Technical Service Bulletin

Cobra Motorcycle Mfg.

TSB0709 ’09 65 engine components

November 18, 2008

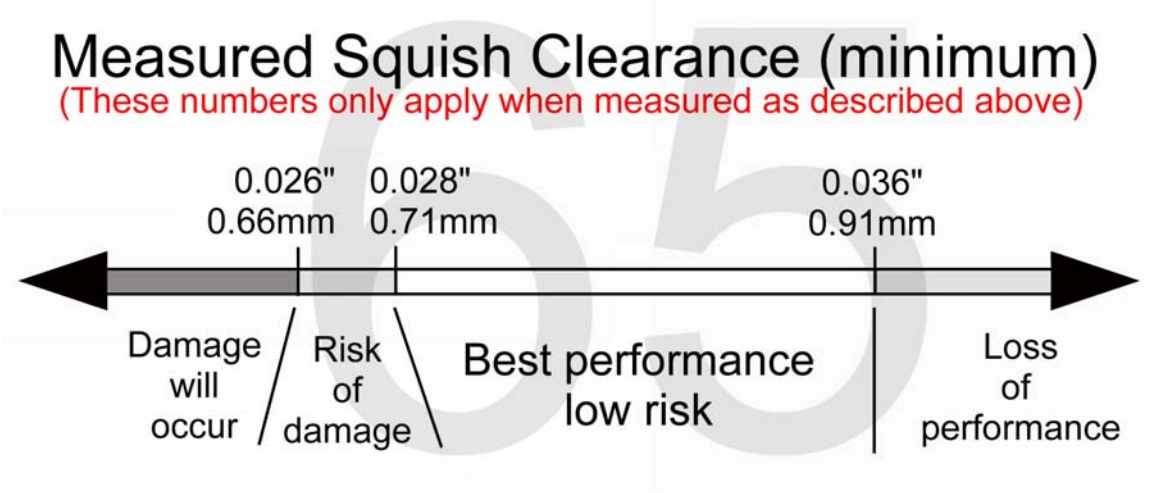
The engine cases and cylinder used on 2008 CX65 have been replaced for 2009 and are no longer available for service replacement. Also, the 2008 cylinder is no longer available for service replacement. Older model cases, cylinder and head can be used interchangeably as long as appropriate base gaskets are used to achieve the acceptable squish clearance.

2008	2009
Engine Case Set	**EKC62008**	**EKC62009**
Cylinder Kit	**ECC60026**	**ECC60017**
Cylinder Head	**ECC60023**	**ECC60029**
